BUILDING INSPECTION

Permit Number: 081106

This is to certify that WOJCIK RAYMOND T & TATA A WOJCIK & Hills Portland Build
has permission to Demolish existing garage (20' x 20') & build in attached front attached to existing building to improve lot c
AT 126 NORTH ST 012 H014001

City of Portland, Maine - Building or Use Permit Application

Proposed egress

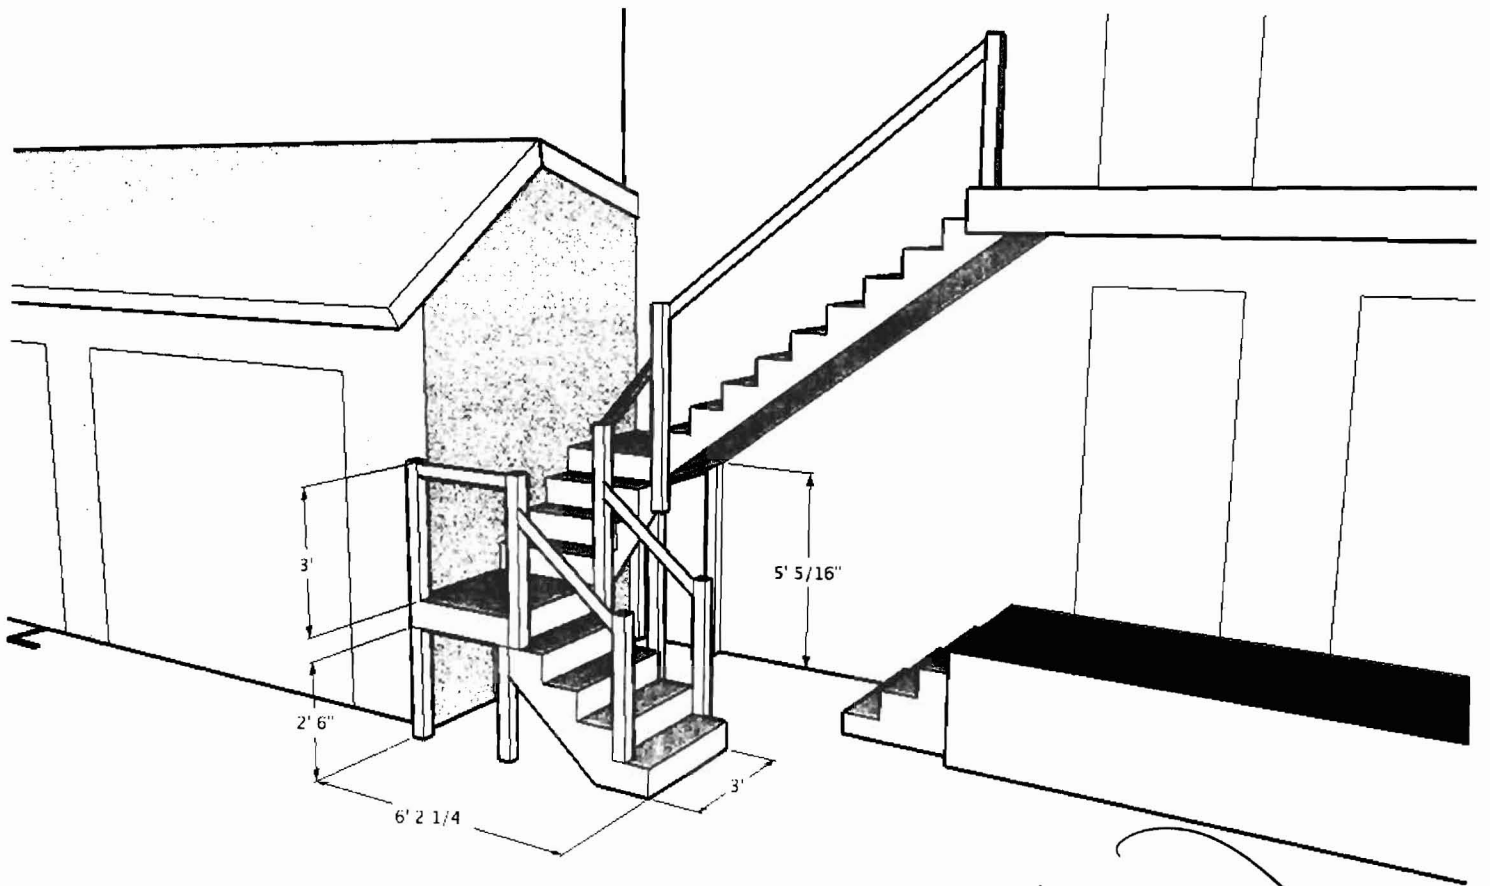
(MUST Add
Ballastres per IBC
and 7" - 11" req.
C.H.
7/20/08

Proposed Garage - plot plan

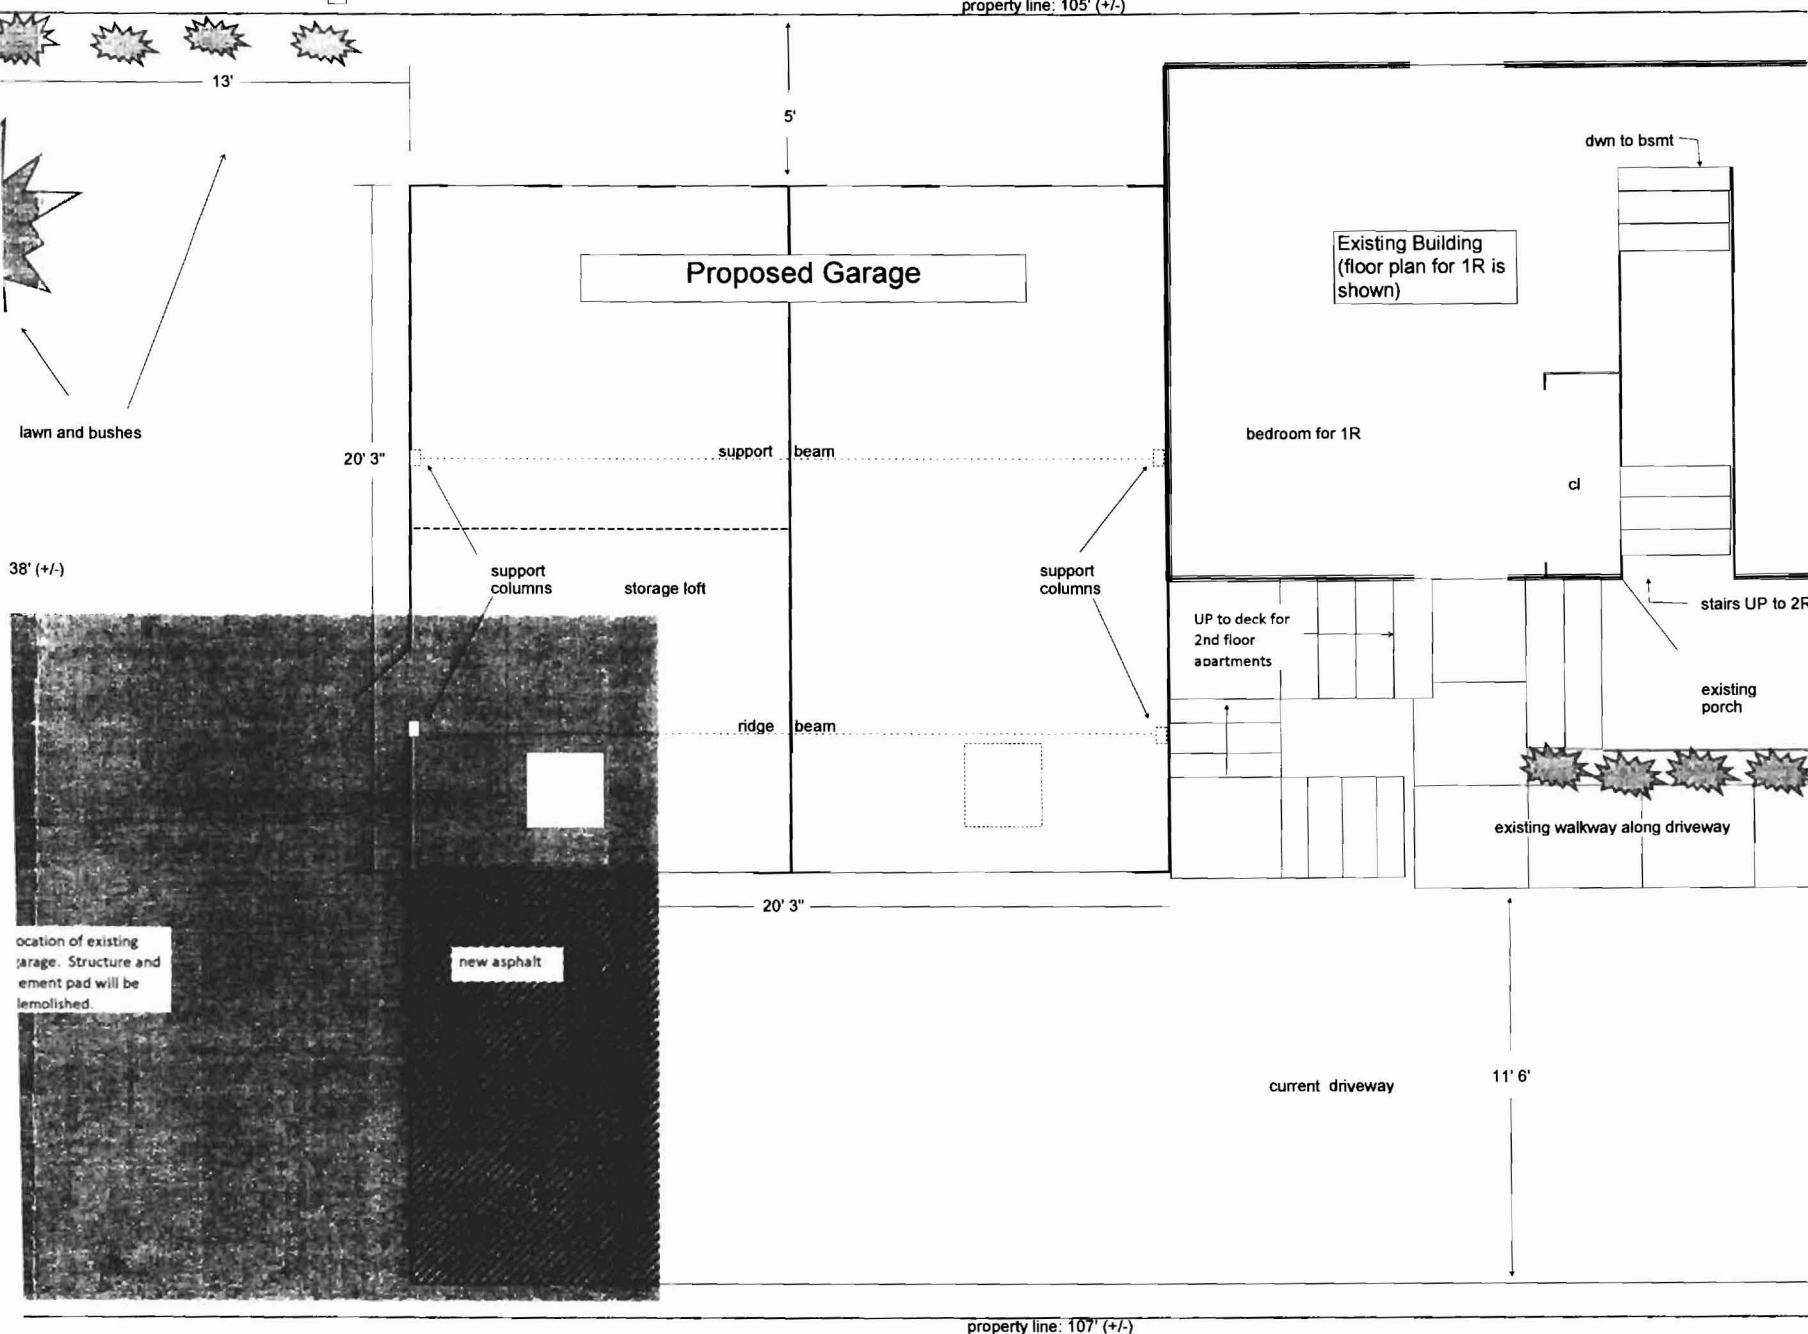
R-6
 lot size = 41015
 land area per acre = 1,200 sq ft.
 rear - 20' - 13' is better than before
 side - 10' - 5' is better.
 - stairs 10' ok.
